MEMORANDUM FOR: RECORD

July 9, 2015

SUBJECT: DETERMINATION REGARDING THE SUITABILITY OF PROPOSED DREDGED MATERIAL FROM GEORGIA-PACIFIC GYPSUM, EVALUATED UNDER SECTION 404 OF THE CLEAN WATER ACT, FOR UNCONFINED OPEN-WATER DISPOSAL AT THE COMMENCEMENT BAY NONDISPERSIVE SITE.

Figure 6

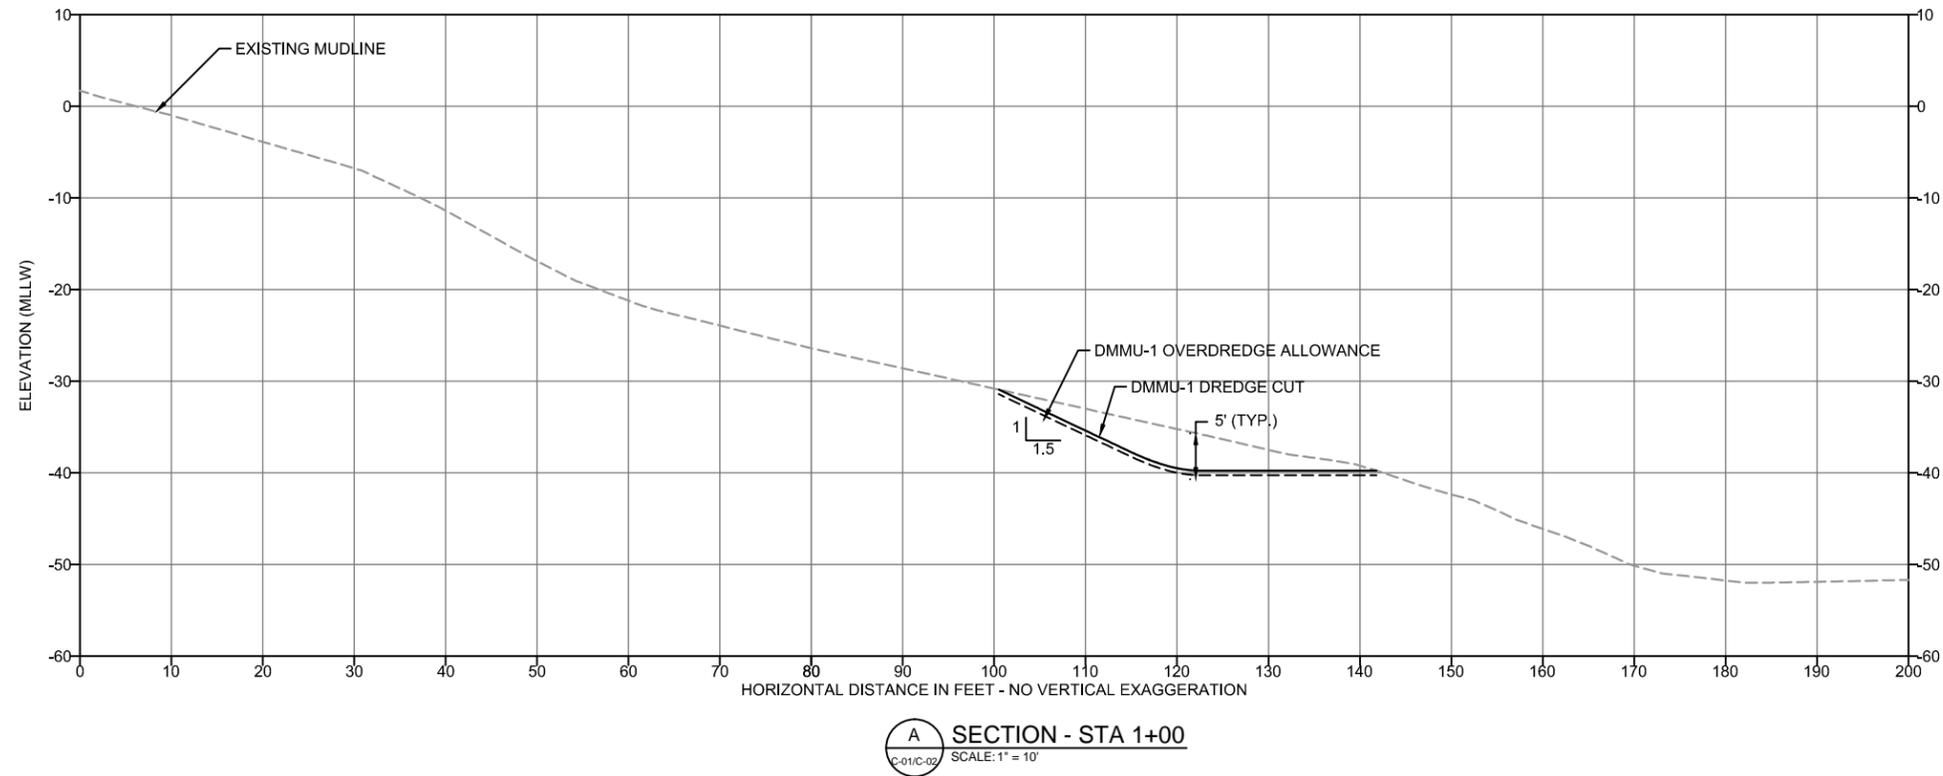
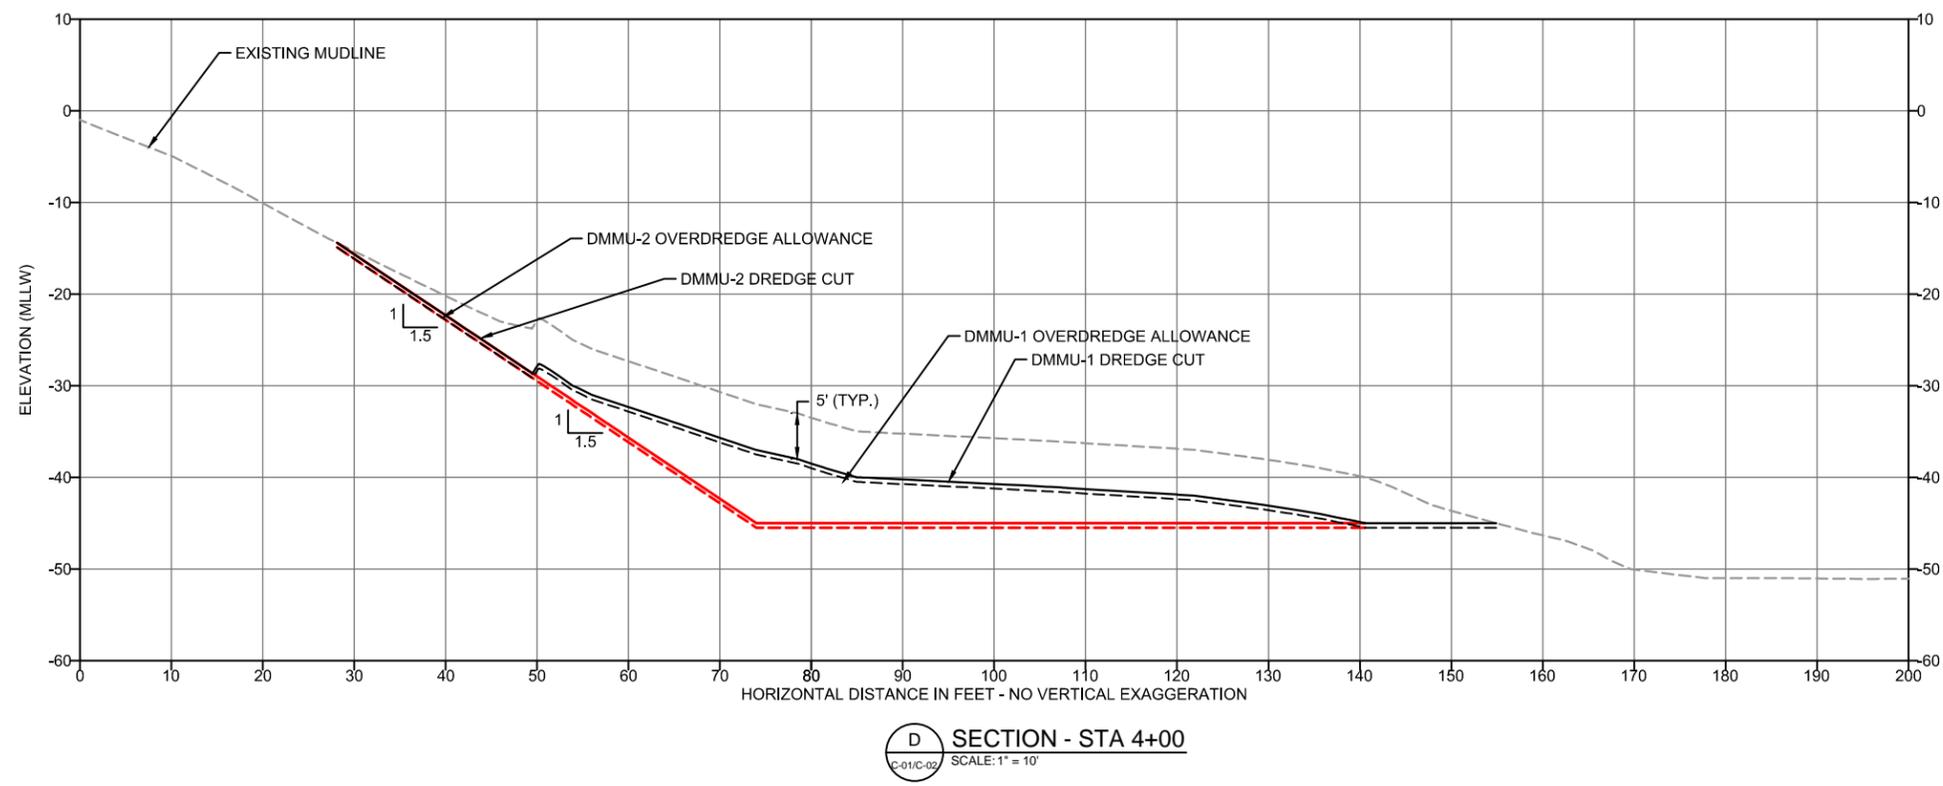
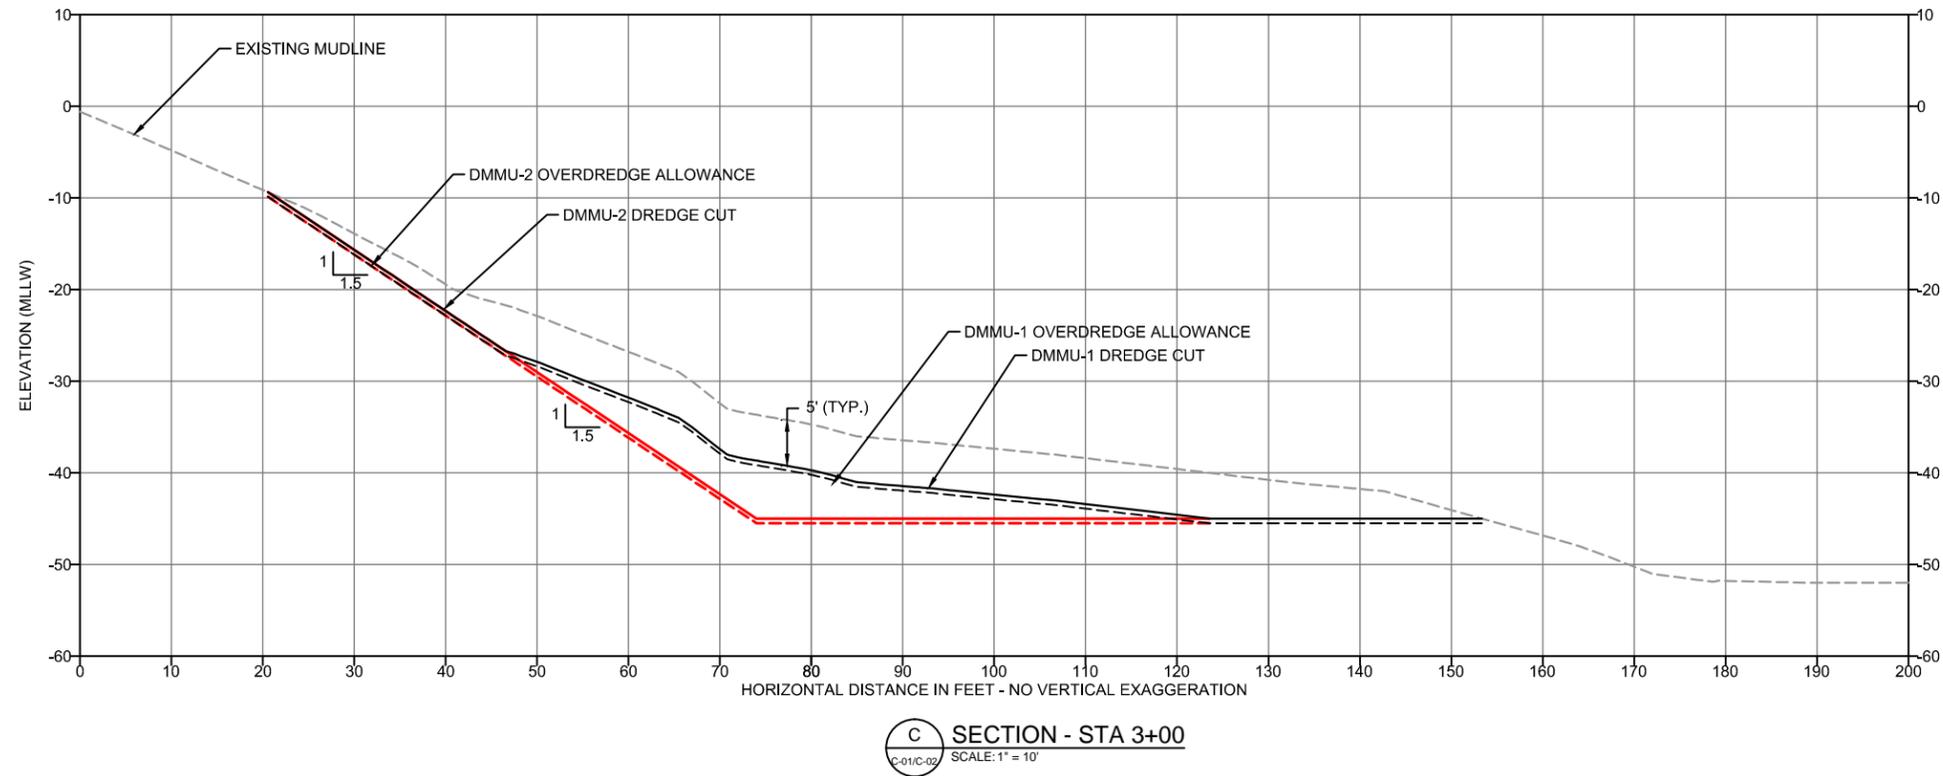
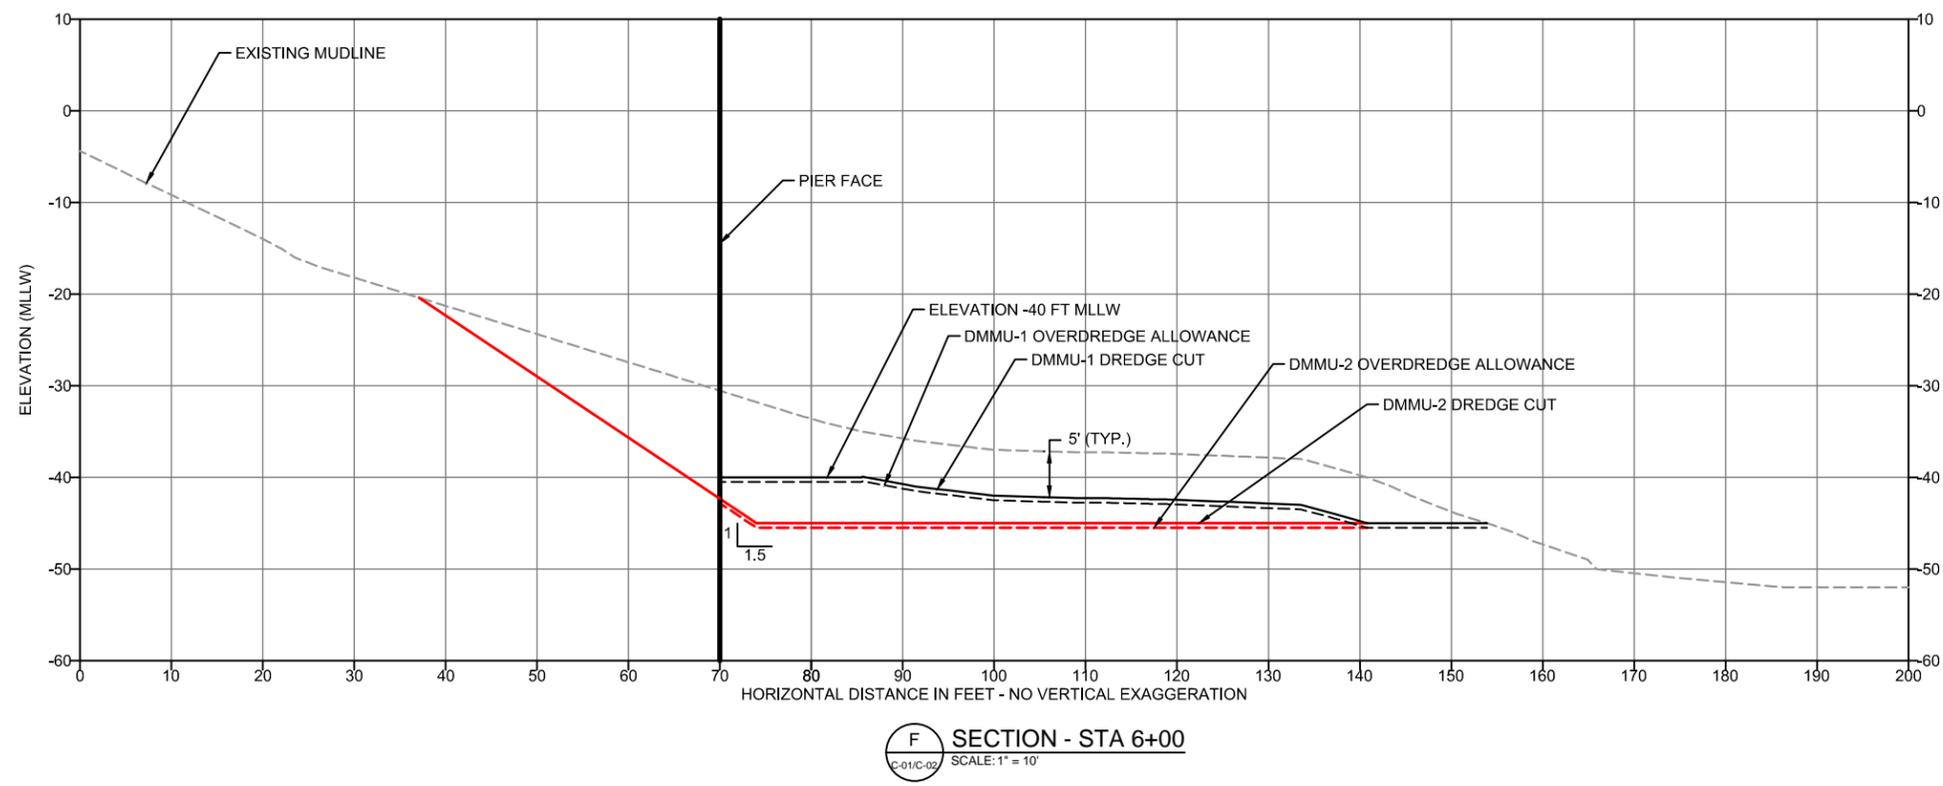
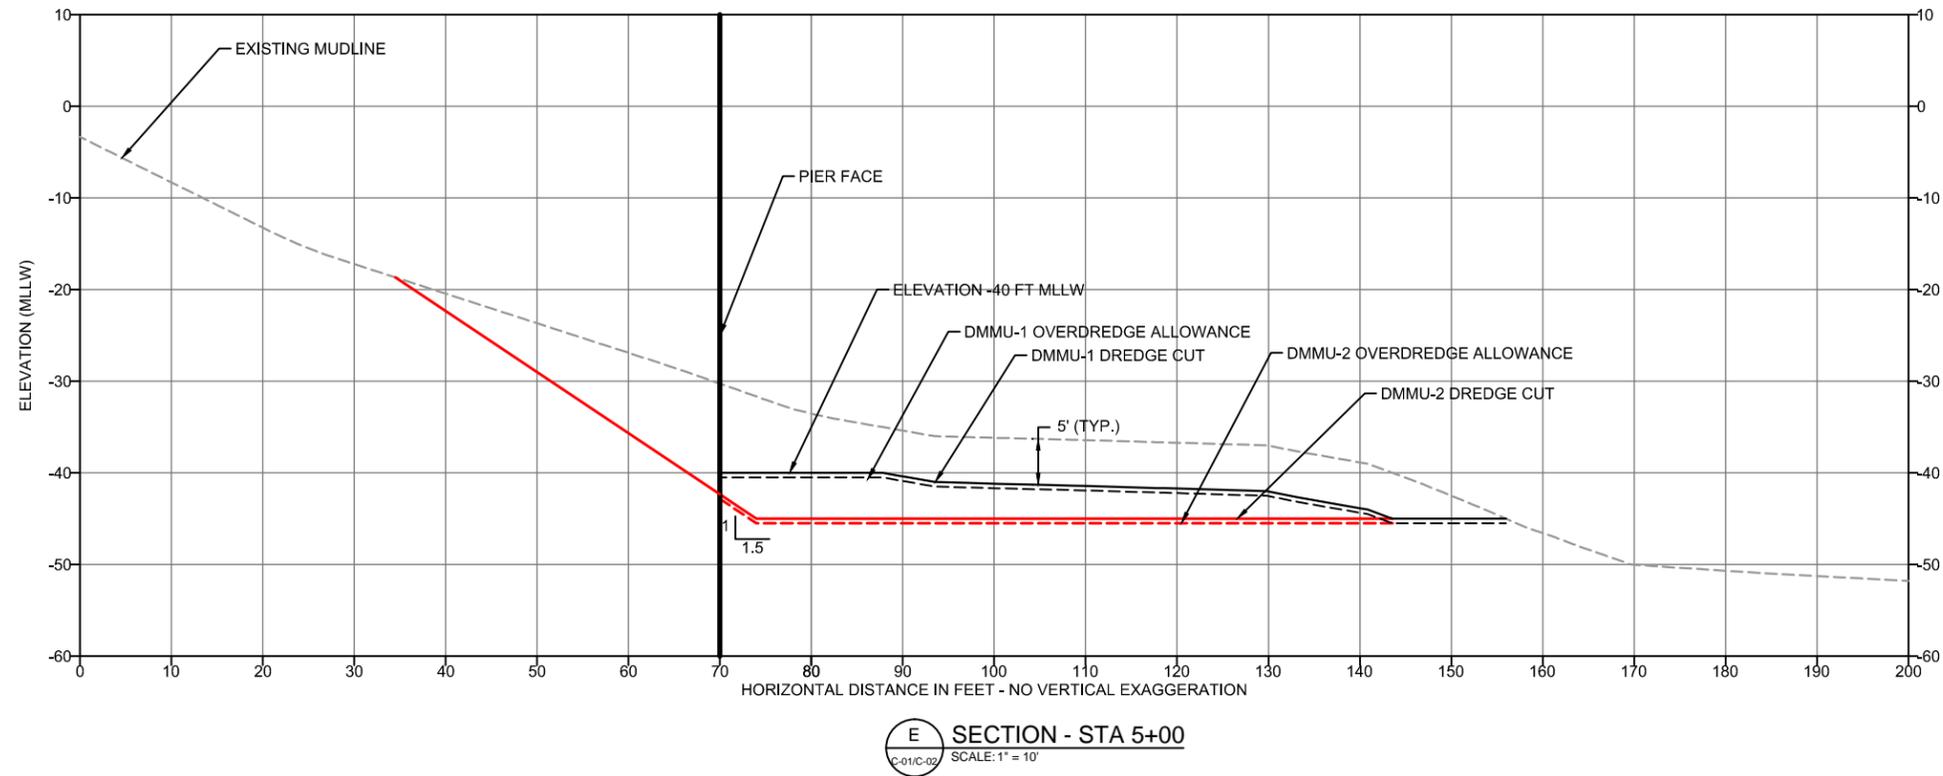
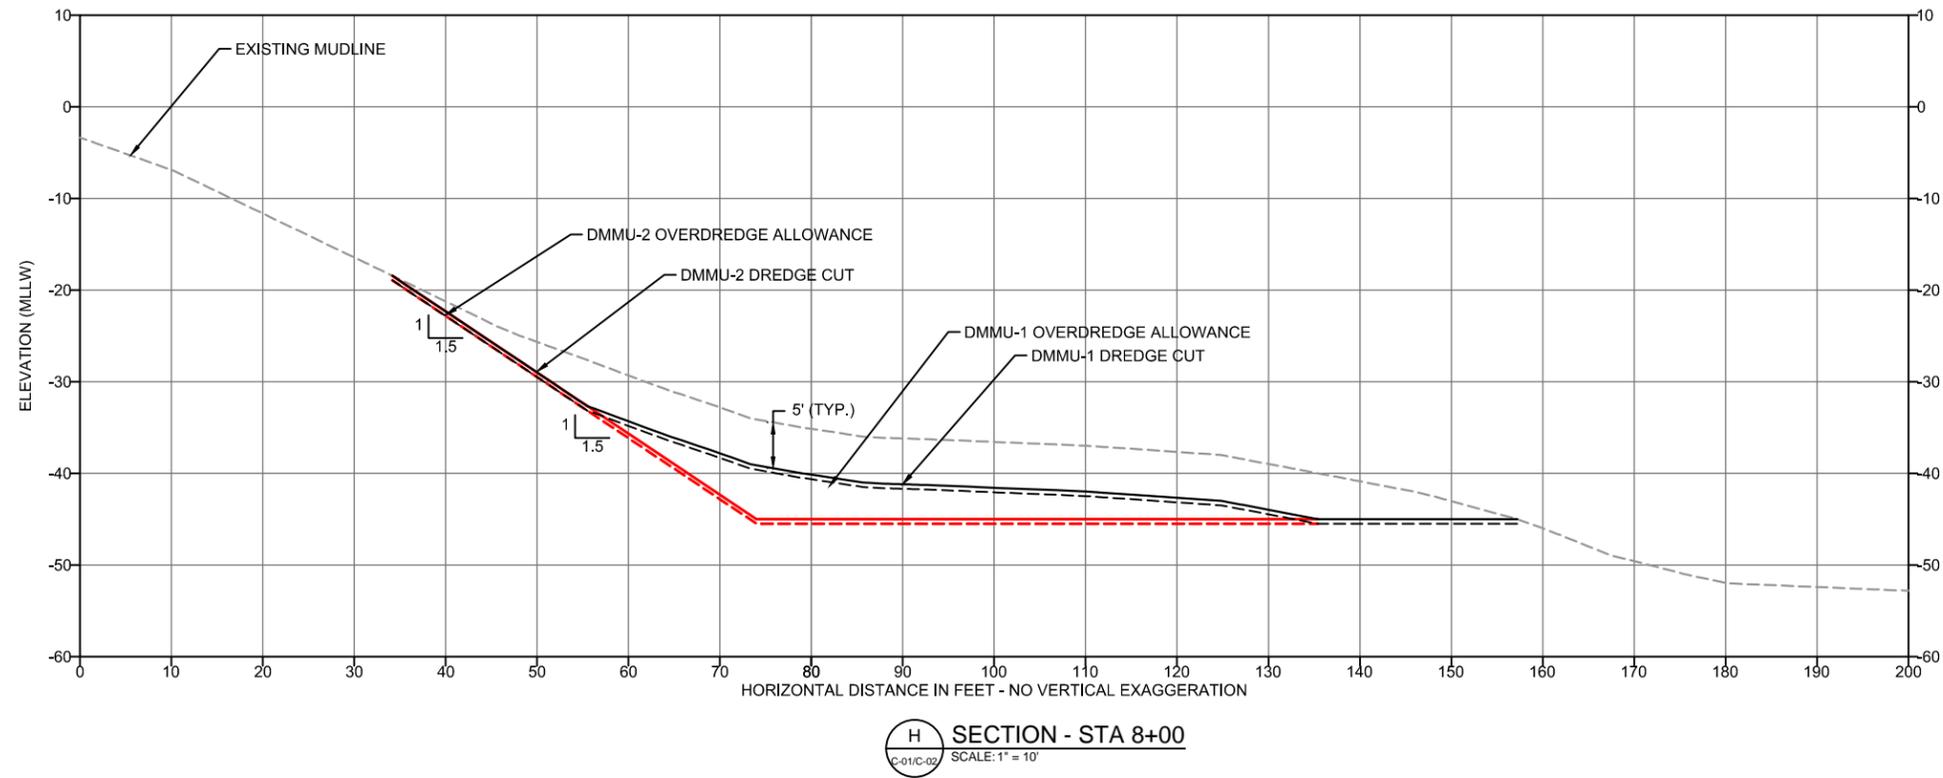
In order to adequately separate the unsuitable surface material from the suitable subsurface material during dredging, the DMMP agencies are requiring a one-foot vertical buffer be added to DMMU 1. This means that the surface five feet (not including overdepth), must be dredged and hauled to an upland disposal site. Once the surface material has been removed, the remaining sediment may be dredged and placed at the Commencement Bay open-water disposal site.

GPG has submitted a preliminary dredge design (Figures 4 to 10) that includes the one-foot buffer. The dredge prism also includes other changes from what was presented in the SAP. In order to minimize potential impacts to Graymont Incorporated's dock to the northwest, the northern extent of the dredge prism was reduced. In addition, the overall dredge depth was changed to -45.5 ft from the depth of -45.0 ft included in the SAP. The design depth is now -45.0 ft plus a 0.5 ft overdredge allowance.

The modifications made to the dredge plan resulted in an overall reduction in the total volume from 28,710 cy to 25,450 cy. Due to the addition of the one-foot buffer, the volume of DMMU 1 increased from 14,330 to 16,900 cy. The subsurface volume included in DMMU 2 shrank to 8,550 cy.

In summary, based on the results of the previously described testing, the DMMP agencies concluded that the **16,900 cubic yards of dredged material in DMMU 1 are unsuitable for open-water disposal, while the 8,550 cy in DMMU 2 are suitable for open-water disposal at the Commencement Bay non-dispersive site.**
